City of Santa Barbara
Community Development

SUBJECT: REVISED: Staff Report for Appeal Regarding 28 Anacapa St, Unit E

BRASS BEAR BREWING

TENANT IMPROVEMENTS TO EXISTING COMMERCIAL LEASE SPACE

ENLARGED SITE PLAN - EXISTING AND PROPOSED

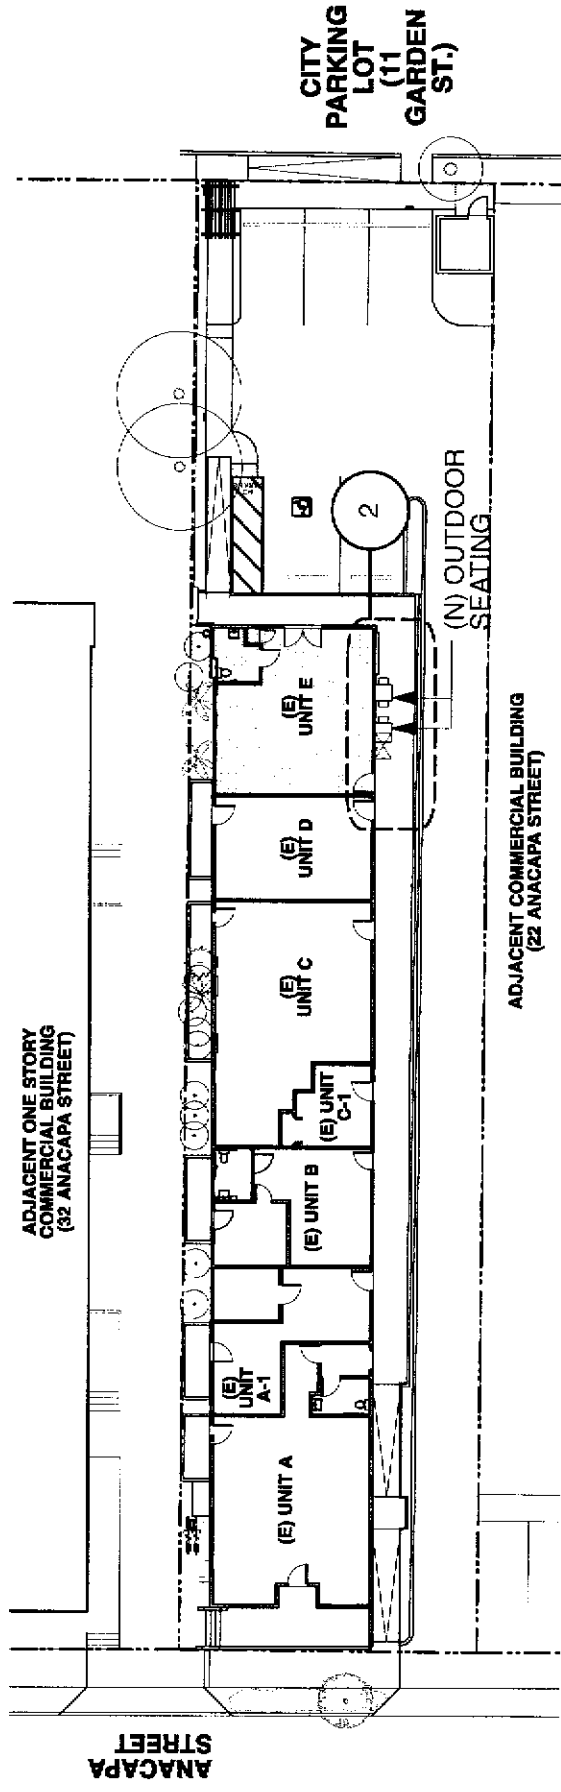
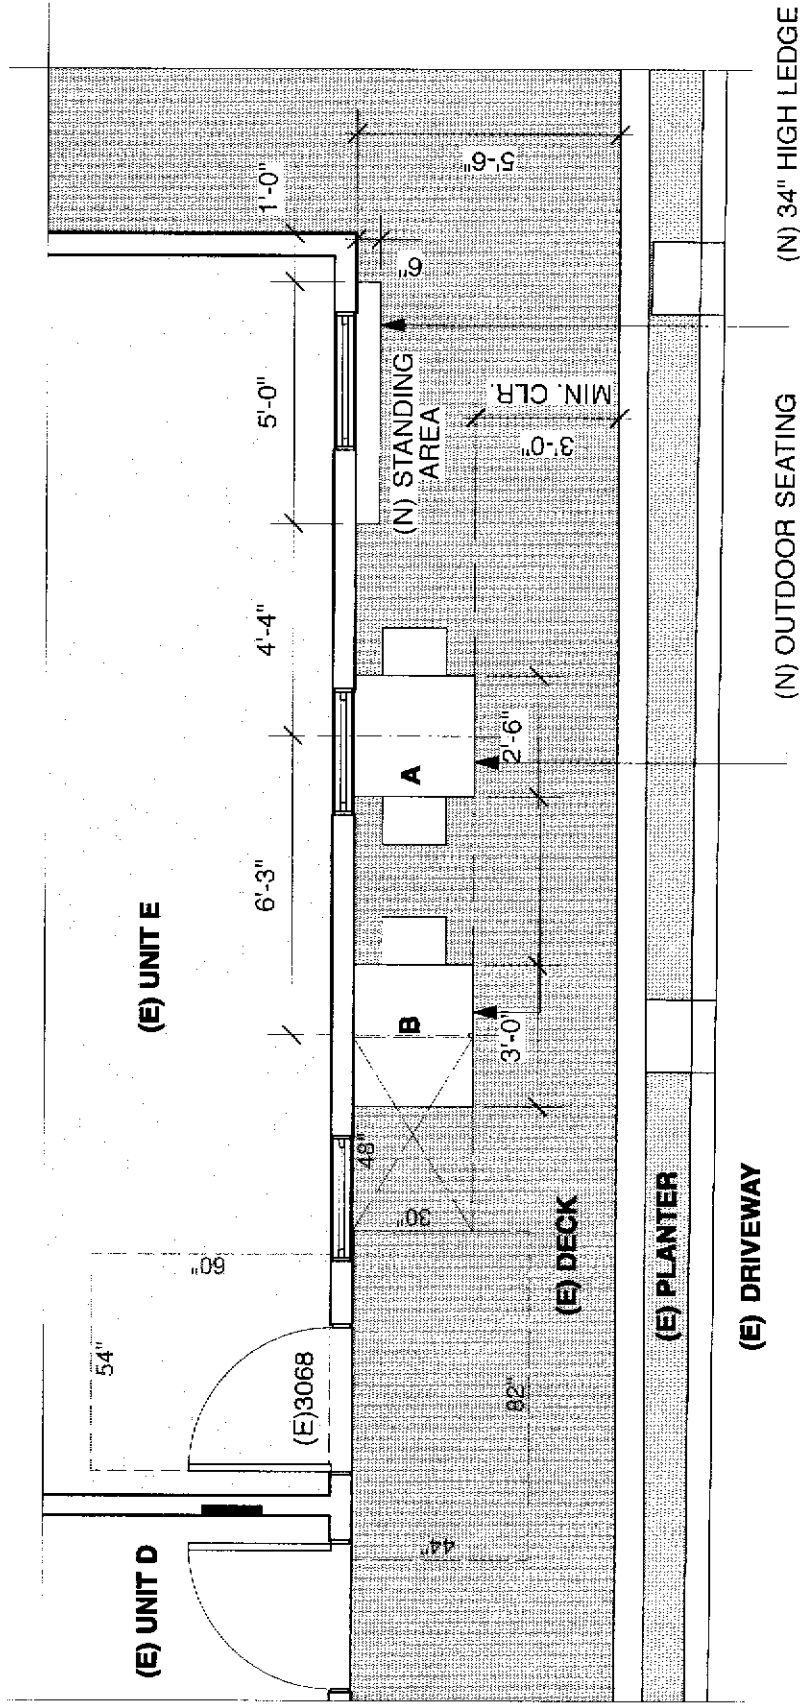
On July 25, 2016, a new permit application was submitted to: “*Install two fixed outdoor dining tables on the exterior deck for Brass Bear Brewing.*” Unfortunately, the exterior seating that is proposed encroaches into the minimum required 48” path of travel and exit discharge. Since the brewery use was established in 2015 via a fully code compliant set of plans and permits, staff cannot reduce the 48” path of travel width requirement by citing the “existing conditions” provisions found in Section 11B 403.5.1 exception #3 of the 2013 California Building Code.

In this case, the occupancy changed from a hair salon to a brewery in 2015 and the required 48” wide path of travel was provided for the required exit discharge system and accessible path of travel between the City parking lot and Anacapa Street. Even though the core building is much older, the deck area and current occupancy were significantly altered within the past 3 years and include a fully compliant accessible path of travel. With this in mind, staff finds that the minimum path of travel width must be 48”.

proposal is for new outdoor dining and standing area, not an existing condition.

3) As was discussed at the counter when this project was first proposed, the minimum 48" wide path must be provided for accessibility.

4) If the 48" wide path can be provided, new plumbing fixture calculations would need to be done for the unit associated with this proposal to ensure enough plumbing fixtures are provided for the new occupant load.

2) Show the elevation of the deck and the Base Flood Elevation on the plan so that it is clear that all work is above the BFE.

ENLARGED SITE PLAN - EXISTING AND PROPOSED
SCALE: 1/4" = 1'-0"

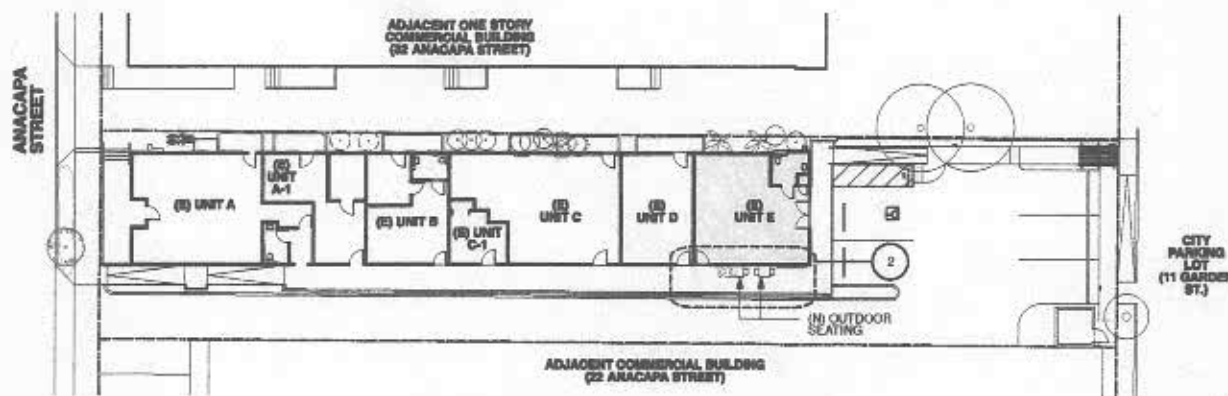
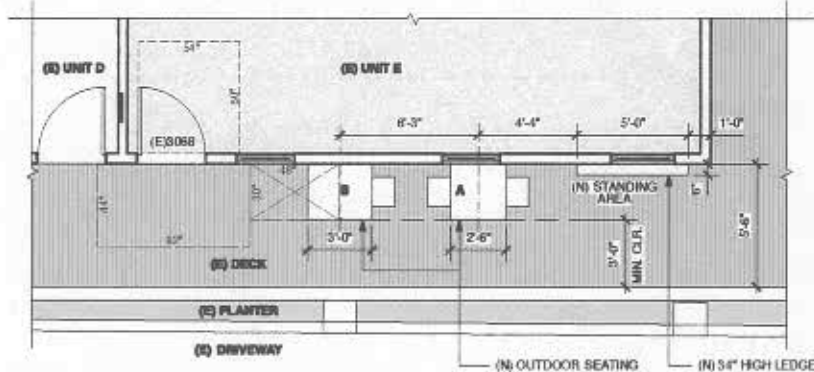
The Building Official may not be seeing this condition as an existing constraint, but in fact it is. In order to provide a 48" wide walkway in addition to the smallest width of exterior seating, we would need to remove the south wall of the building and the roof, as well as construct a new foundation under a new wall. This would essentially require significant (if not complete) demolition and reconstruction of this building. The driveway is existing and being maintained at its very minimum 10' wide dimension. A small landscape planter was essential for softening the driveway and required by the Architectural Board of Review, for good reason, we feel. The landscape planter provides a basis for the planting on the exterior railing. We constructed the deck and accessible path of travel as wide as we were able to do.

Had this been an enclosed deck with seating along it, only 36" would have been required. It is the exterior path requirement that is 48". In other words, had the Owner decided to add enclosed space rather than exterior patio, only 36" would have been required. We felt the exterior dining was much more suitable and a much better design for this property.
